Airworthiness Directive

AD No.: 2025-0205R2

ATR 42 and ATR 72 aeroplanes

ATA 53 – Fuselage – Passenger Seat Tracks – Inspection / Replacement

Appendix 2- Identification of 'UACE' seat tracks manufactured in or after 2024

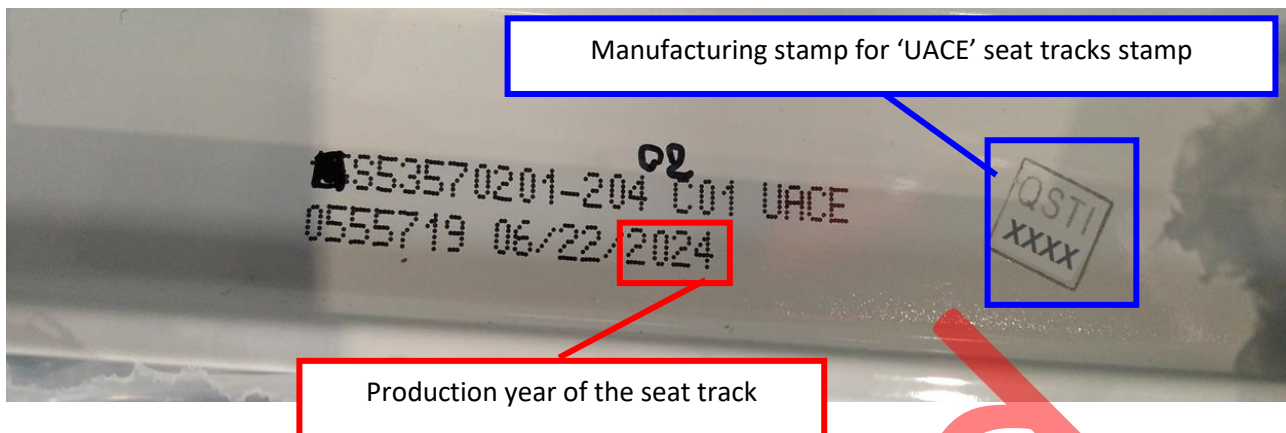
The identification of the seat track is located on the lower face of the seat track.

The manufacturing stamp of the seat track on the illustration corresponds to 'UACE' manufacturer, where 'XXXX' represents any numerical sequence.

The production year of the seat track on the illustration is 2024.

All the seat tracks having this manufacturing stamp and a production year equal to or above 2024, do not have to be considered as affected parts.

All the seat tracks with the manufacturing stamp and/or production year not visible/legible, have to be considered as potential affected parts.
